Subject: **D2 BOARD MODIFICATION**

Model: **PVM-3230**

Serial No: **2,000,001-2,000,800**

Figure 1

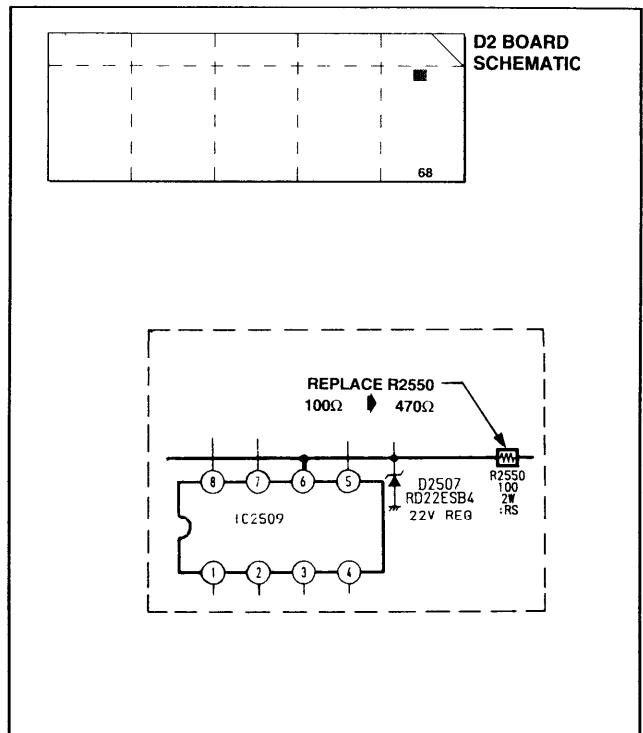
To improve the reliability of D2507 on the D2 board in a high temperature environment, replace R2550 as shown in Figure 1.

Part No.	Description	Qty.
1-215-890-11	Res, Metal, 470Ω, 2W	1
